CV2262

Specification AD/CV2262. Issue No. 5 dated 24.10.58. To be read in conjunction with K1001	SECURITY Specification: Unclassified Valve: Unclassified

TYPE OF VALVE: Magnetron, X-Band, packaged, pulsed, tunable.

SPECIFICATION AD/CV2262
ISSUE NO. 5 DATED 24.10.58

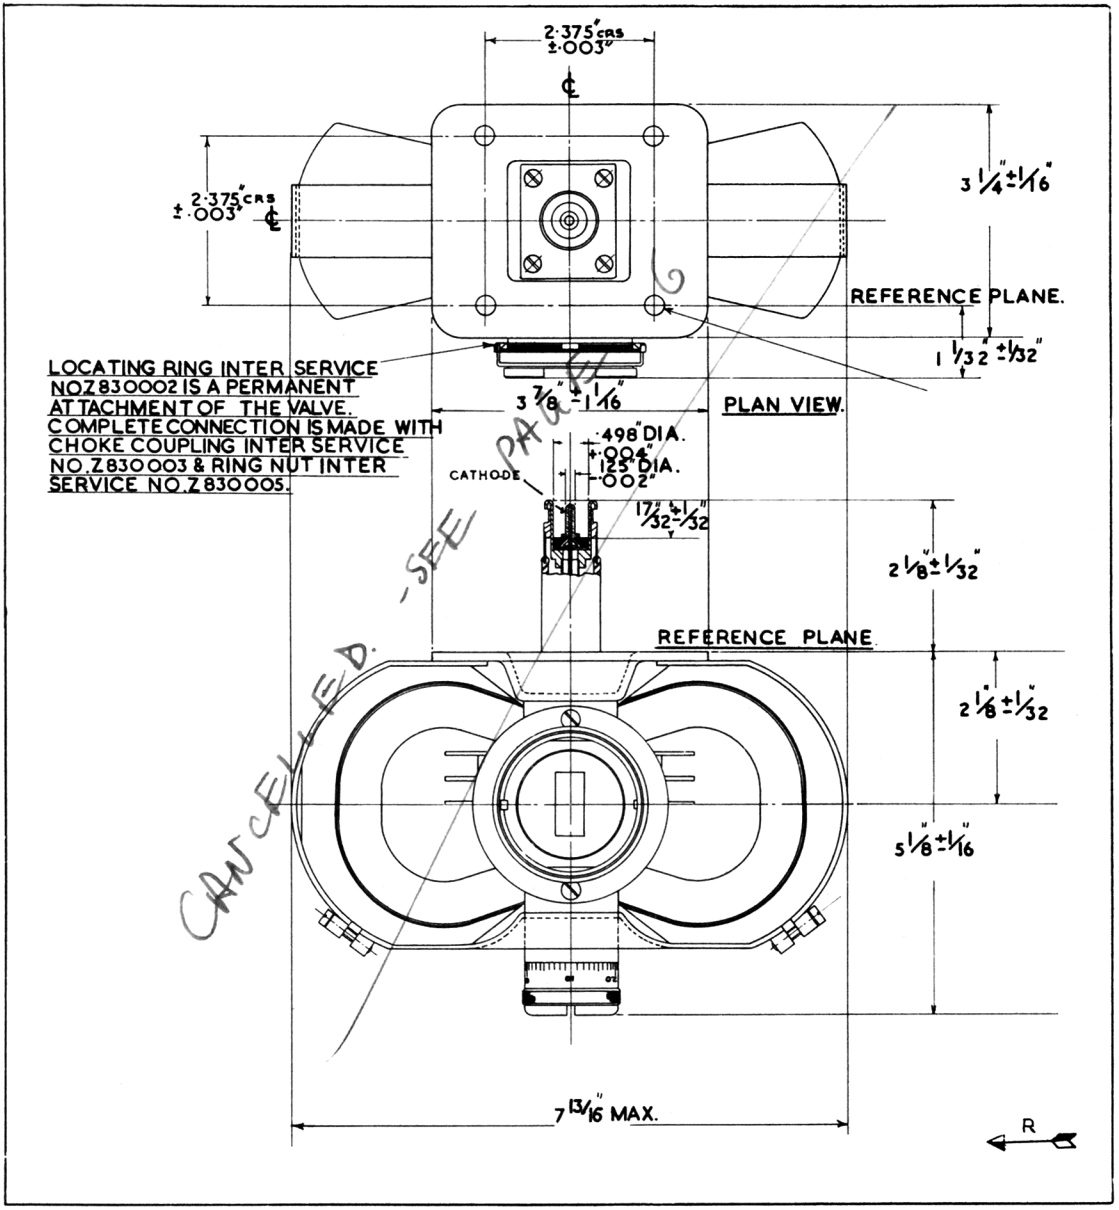
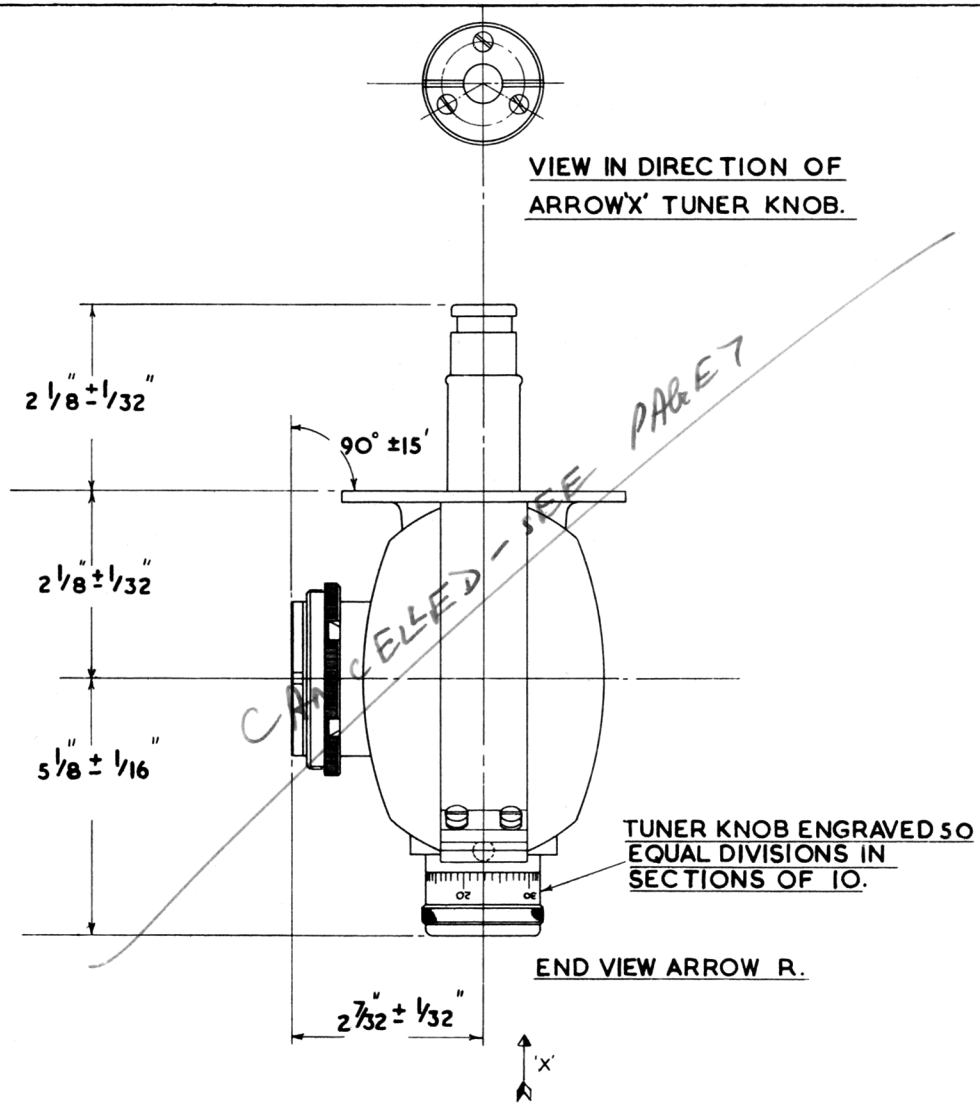
Insert new Pages 6 and 7 attached.

Endorse existing Page 4 "Cancelled - see Page 6".
" existing Page 5 "Cancelled - see Page 7".
